Access Compliance Report
Public Rights-of-Way
(Pedestrian Signals)

Intersection ID: N/A	Main Street:		Cross Street: N/A		Location: N/A

ADA ID: FDAE70C6C01B **Signal Type:** One Push Button-APS **Overall Compliance:** No **Severity Score: BTN 1:** N/A **BTN 2:** N/A **No BTN:** N/A

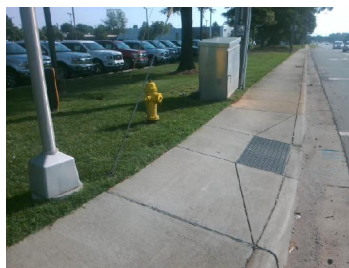
Surveyor Notes: TEXT HT 5/16

PROW/ADA: R410.6, R209.1, TMUTCD 4e.08, R404.2, R404.7.3, TMUTCD 4e.10, MUTCD 4e.08, MUTCD 4e.10, R104.2,

Compliance	Description	Data	Compliance	Description	Data
Yes	B 1 Clear Xing Direction?	ClearlyMarked	N/A	B 2 Clear Xing Direction?	N/A
	B 1 Crossing Direction	To SE		B 2 Crossing Direction	N/A
Yes	B 1 DistanceTo XWalk (in)	14.0	N/A	B 2 DistanceTo XWalk (in)	N/A
No	B 1 DistanceTo Curb (in)	80.0	N/A	B 2 DistanceTo Curb (in)	N/A
Yes	B 1 Diameter (in)	2.0	N/A	B 2 Diameter (in)	N/A

Description	Data		Description	Data
	Is Button 1 APS or Non-APS?	APS		Is Button 2 APS or Non-APS?	N/A
No	B 1 VibroTact Arrow?	N/A	N/A	B 2 VibroTact Arrow?	N/A
N/A	B 1 VibroTact Parallel to Xing?	N/A	N/A	B 2 VibroTact Parallel to Xing?	N/A
N/A	B 1 VibroTact Contrast	N/A	N/A	B 2 VibroTact Contrast	N/A
No	B 1 Pilot Light?	N/A	N/A	B 2 Pilot Light?	N/A
N/A	B 1 Pilot Light Illumination?	N/A	N/A	B 2 Pilot Light Illumination?	N/A
No	B 1 Verbal Walk Cycle?	N/A	N/A	B 2 Verbal Walk Cycle?	N/A
N/A	B 1 Verbal Message Audible?	N/A	N/A	B 2 Verbal Message Audible?	N/A
No	B 1 Locator Tone?	N/A	N/A	B 2 Locator Tone?	N/A
No	B 1 Percussive Walk Cycle?	N/A	N/A	B 2 Percussive Walk Cycle?	N/A
No	B 1 Extended Press Feature?	N/A	N/A	B 2 Extended Press Feature?	N/A
No	B 1 Tone Audible Range?	N/A	N/A	B 2 Tone Audible Range?	N/A

Possible Solutions: Replace Signal Push Button With APS Button on New Post. Remove & Replace Sign.
